MEDIC UPDATE
TECHNICAL SERVICE BULLETIN

SUBJECT: STEERING COLUMN NOISE WHEN TURNING			No: TSB-05-54-007
			DATE: September, 2005
			MODEL: See below
CIRCULATE TO:	<input type="checkbox"/> GENERAL MANAGER	<input checked="" type="checkbox"/> PARTS MANAGER	<input checked="" type="checkbox"/> TECHNICIAN
<input checked="" type="checkbox"/> SERVICE ADVISOR	<input checked="" type="checkbox"/> SERVICE MANAGER	<input checked="" type="checkbox"/> WARRANTY PROCESSOR	<input type="checkbox"/> SALES MANAGER

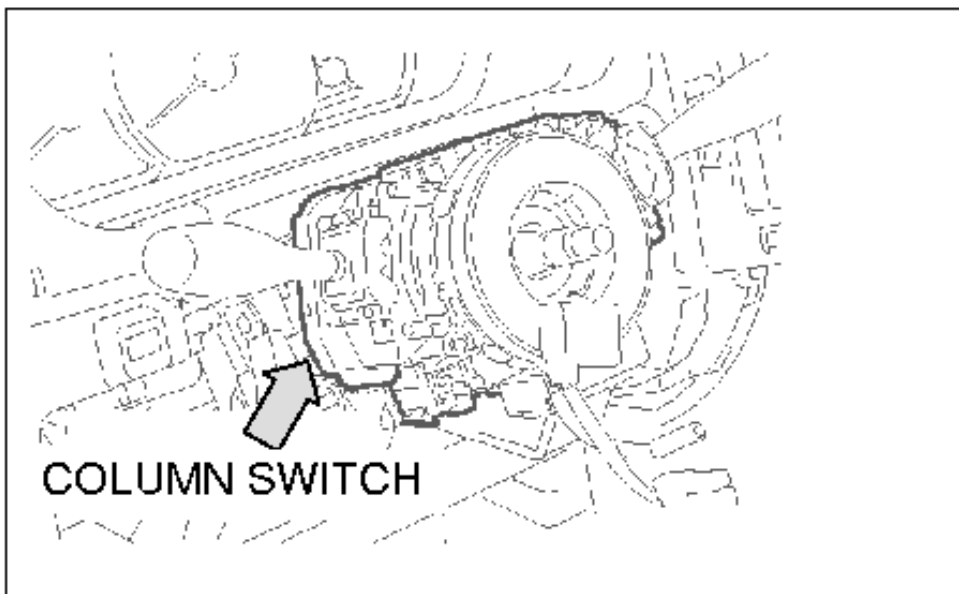
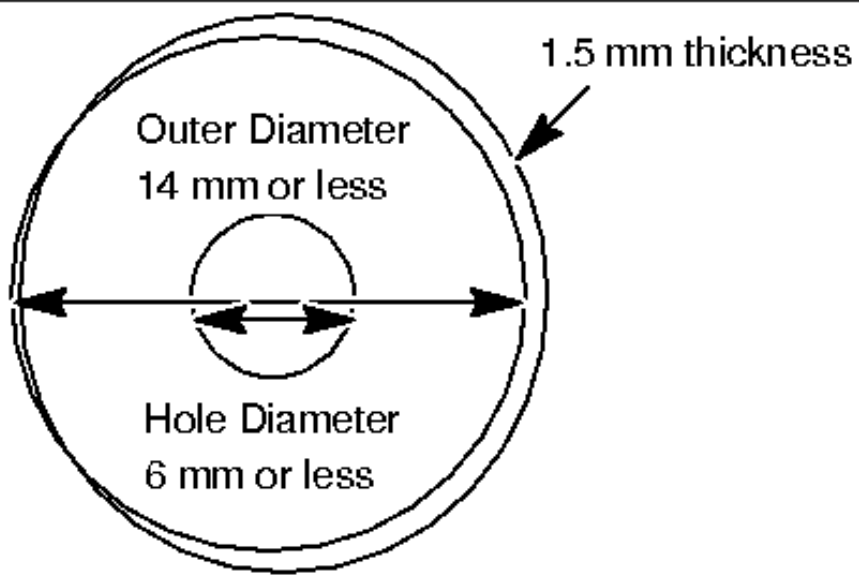
The steering cancel cam on some affected vehicles may not be completely depressed by the steering wheel. As a result, when the steering wheel is turned, the cancel cam tabs may contact the steering column inner housing, creating a rubbing or clicking noise.

Install a washer between the steering column and the switch mounting screw as described in this bulletin. The washer will change the position of the cancel cam, and eliminate the noise.

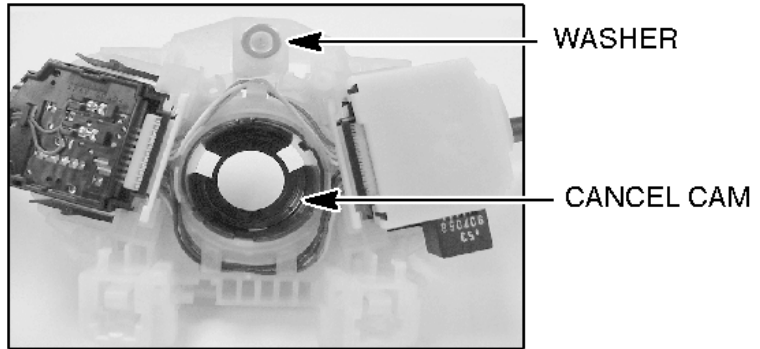
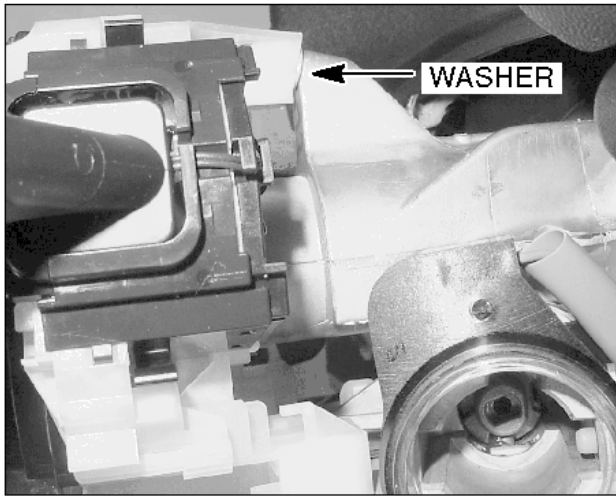
3. Insert the washer over the top mounting screw as shown.

1. Obtain a **1.5 mm thick washer:**

Outer diameter = 14 mm
or smaller
Hole diameter = 6 mm or
smaller.
